Otago Regional Council

Section 42A Staff Recommending Report

Application RM20.280
Dunedin City Council

Subject: Section 42A Recommending Report – Application RM20.280 by the Dunedin City Council for various activities for the purpose of the construction and operation of a Class 1 landfill at Smooth Hill

Figure 1: Watercourse classifications within and downstream of the site

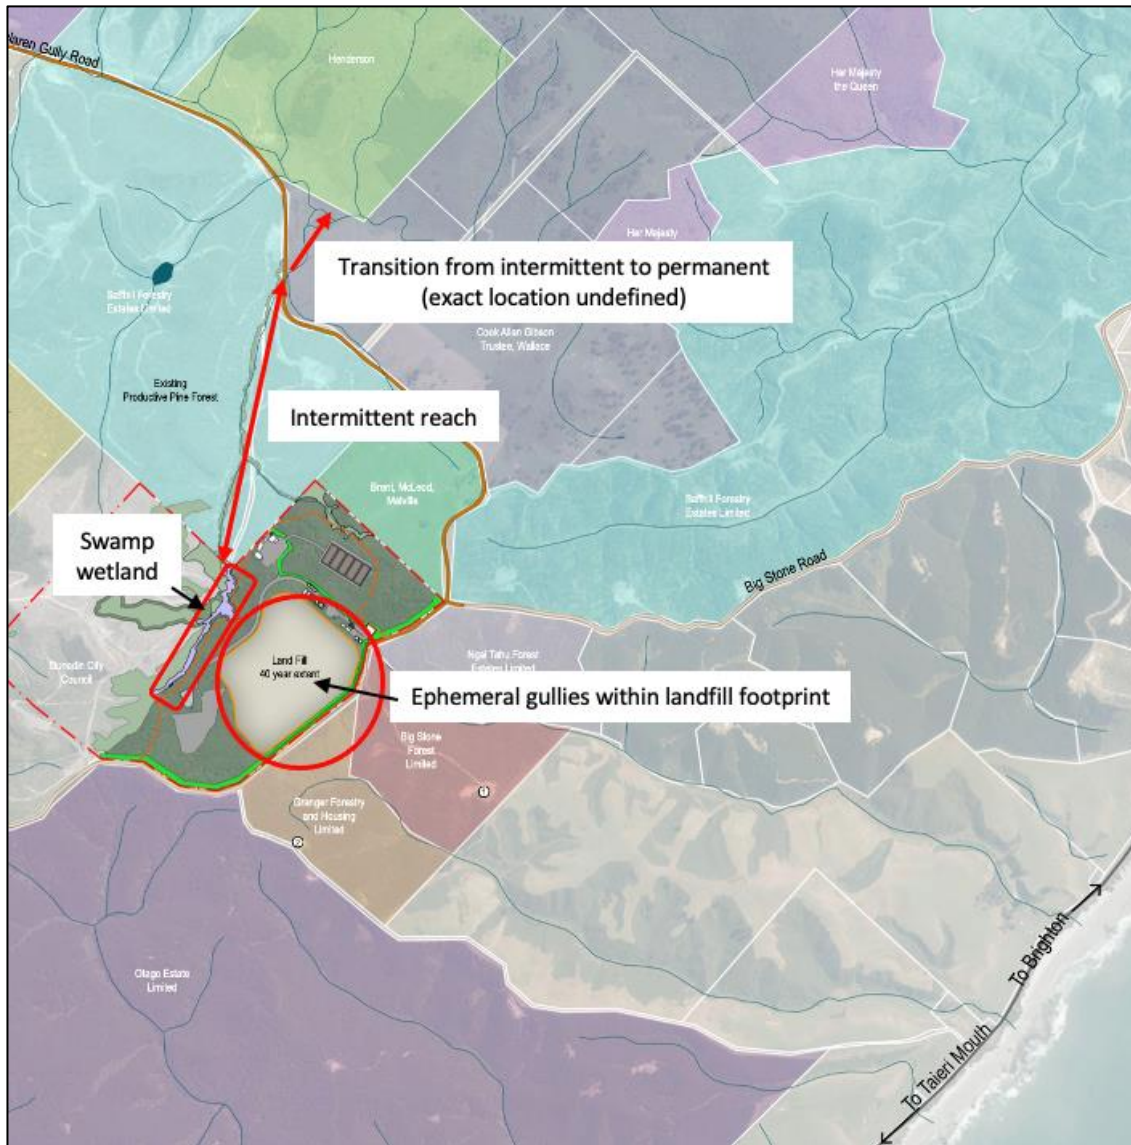
As noted in the Section 7.6 of the s95 report, the applicant has inconsistently applied classifications to watercourses within and downstream of the site. To provide clarity for readers of this report regarding the correct terminology, I have attempted to summarise appropriate classifications on the following plan.
